**MAINE TURNPIKE AUTHORITY**

**ADDENDUM NO. 1**

**CONTRACT 2026.10**

**BRIGE REPAIRS**

SHEET NUMBER: S-15  
CONTRACT: 2026.10  
22 OF 25

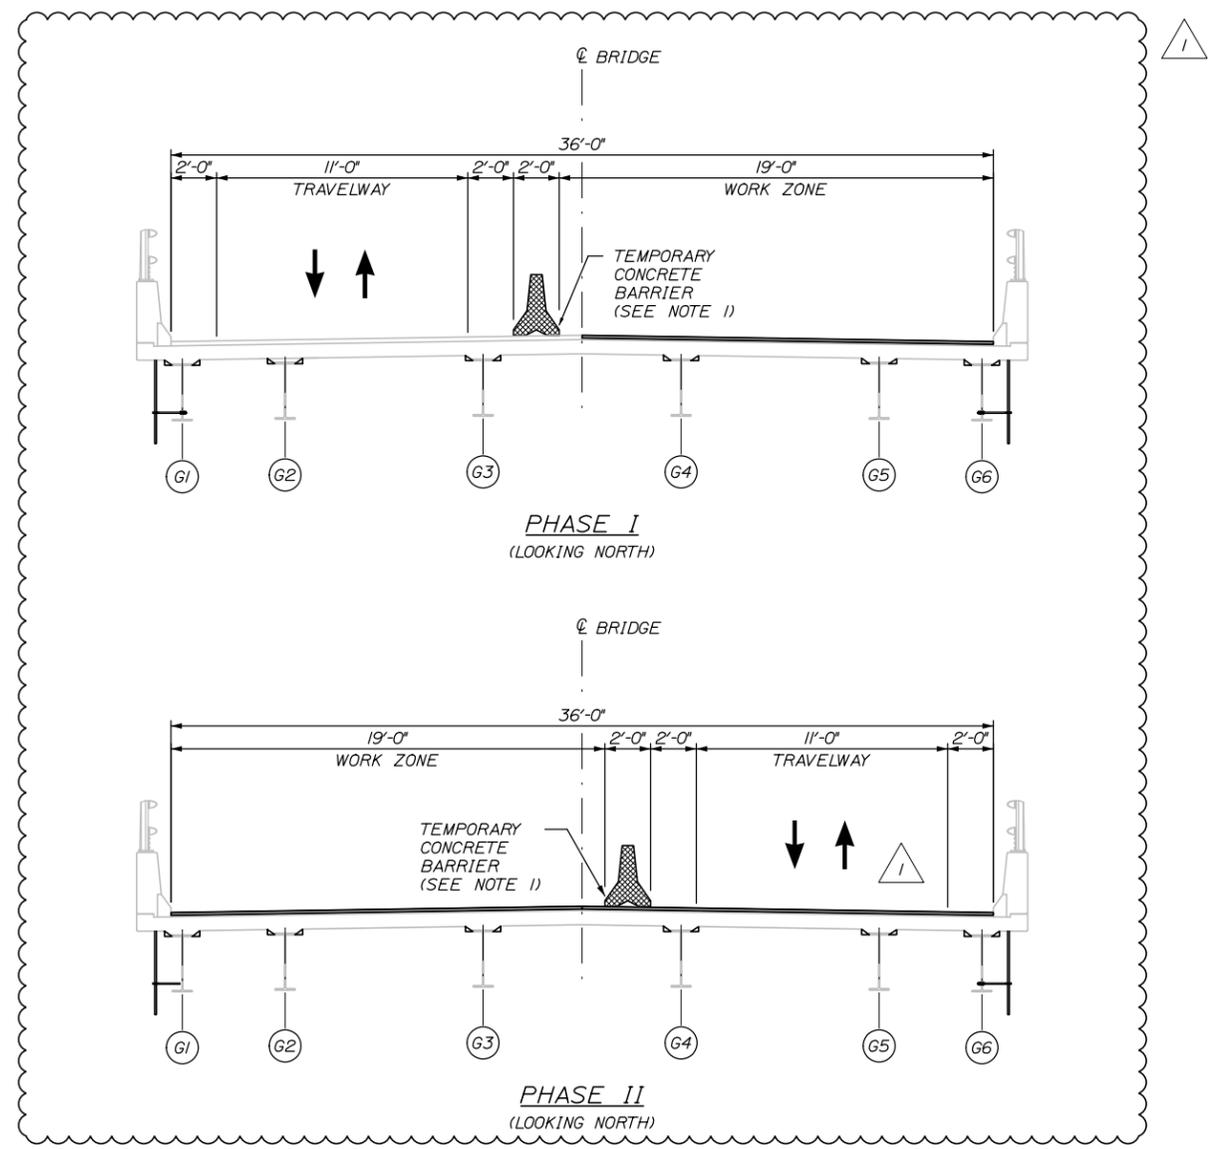
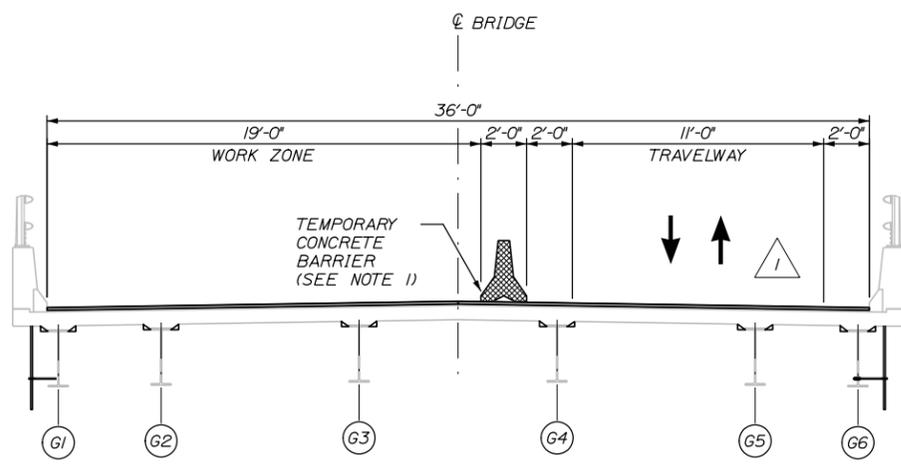
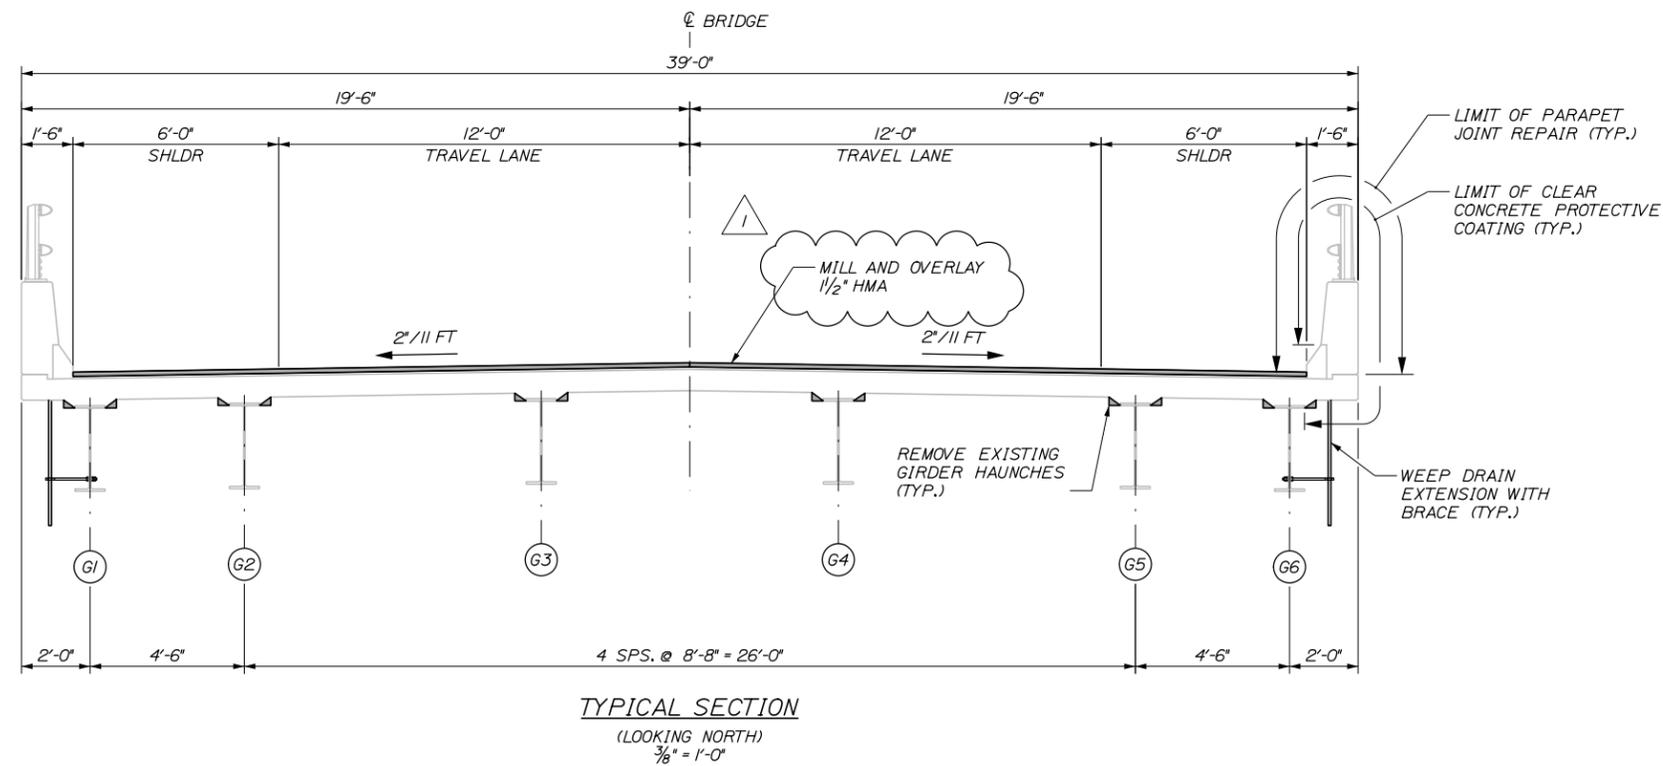
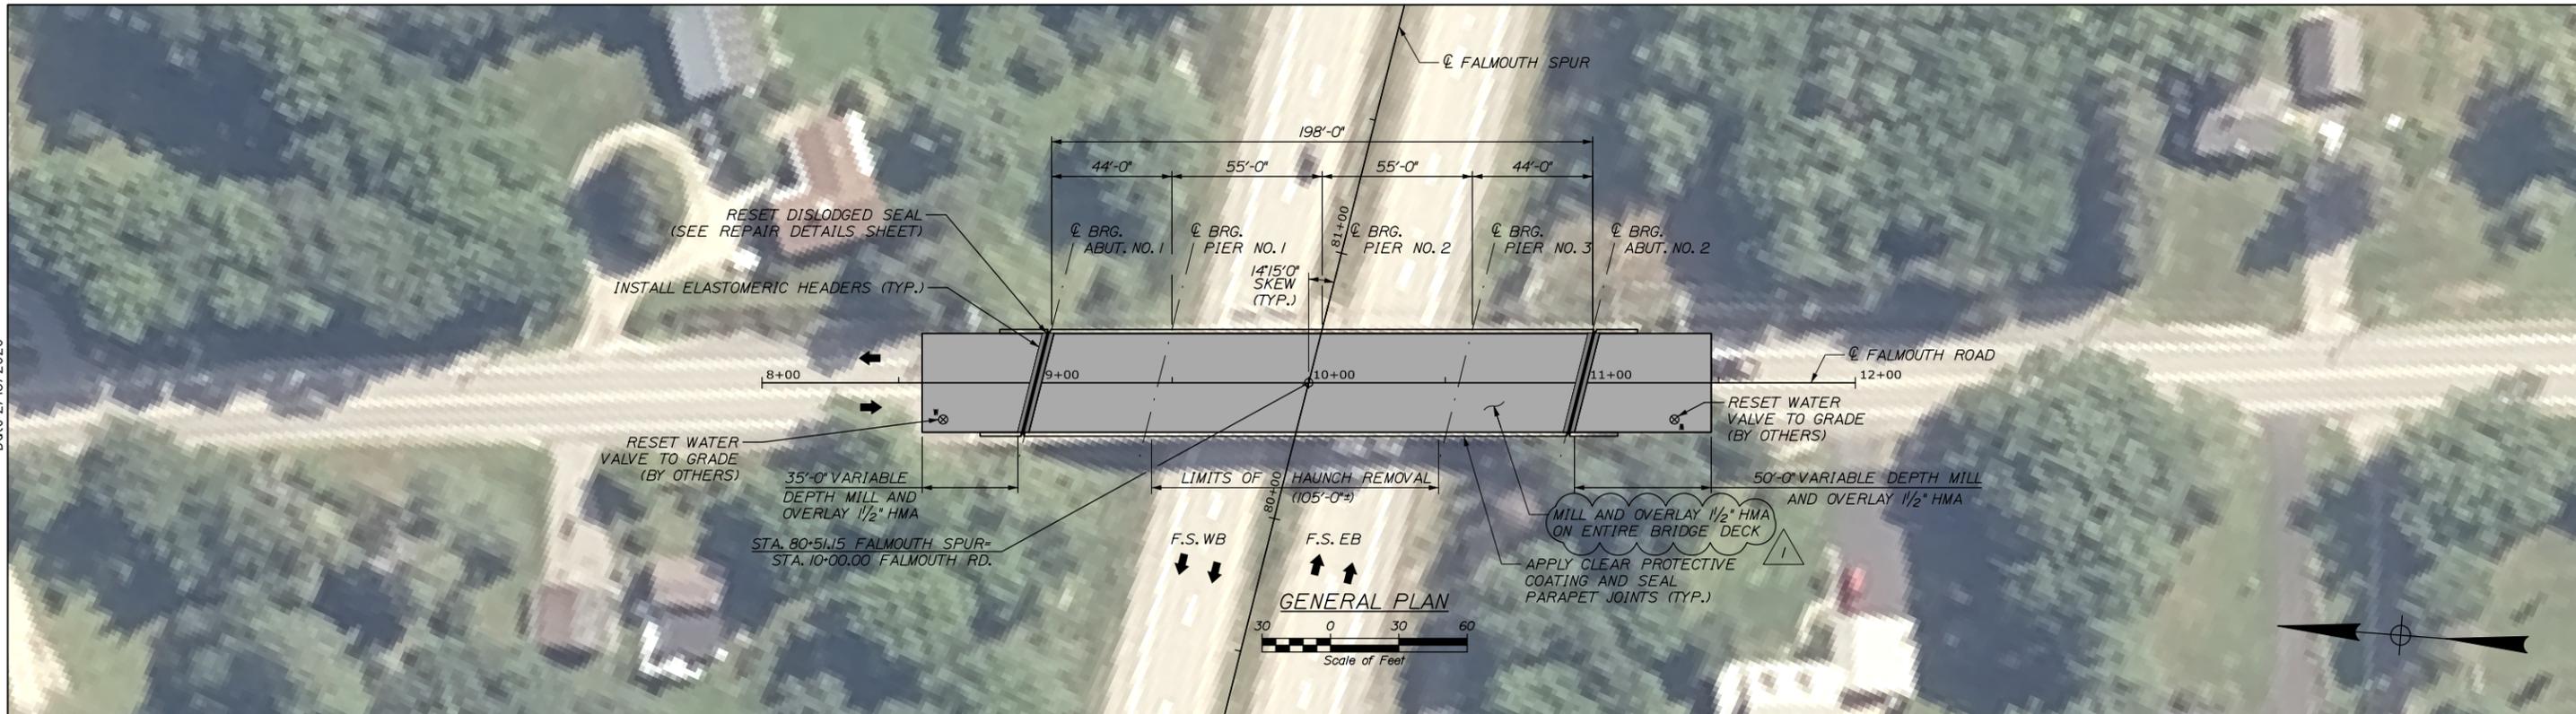
1. Plan Sheet 2 of 25 (QT-1) is deleted and replaced with the revised Sheet 2 attached.
2. Plan Sheet 22 of 25 (S-15) is deleted and replaced with the revised Sheet 22 attached.
3. Plan Sheet 23 of 25 (S-16) is deleted and replaced with the revised Sheet 23 attached.
4. Plan Sheet 24 of 25 (S-17) is deleted and replaced with the revised Sheet 24 attached.

Question 4: At Falmouth Road, when installing the elastomeric concrete header on the bridge deck, how will the header tie into any existing pavement rutting? Will unanticipated milling or additional bridge pavement be required to match grades?

Answer: As part of this addendum, the scope of work for Falmouth Road bridge wearing surface has been revised to require milling and overlay of the entire bridge.

No.	Revision	By	Date
1	Paving Limit Rev	KEB	02/26
